AES Mode for 802.16

IEEE 802.16 Presentation Submission

IEEE S802.16e-04/12

Description of proposed amendments to the 802.16 privacy layer to introduce AES based encryption and authentication.

Privacy/Security

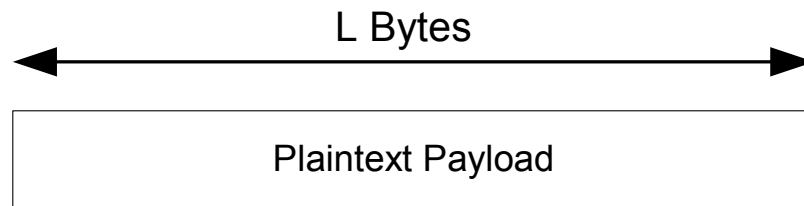
- Diversity in the choice of ciphersuite entries means that the privacy sublayer may now offer more than just privacy.
 - Change name to security sublayer to accommodate new crypto capabilities.

AES-CCM Payload Format

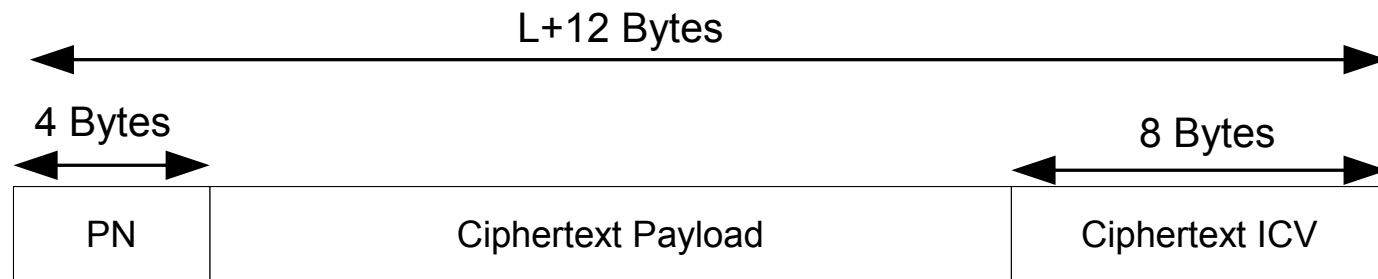
PDU Payload Before Encryption:

PDU Payload After Encryption:
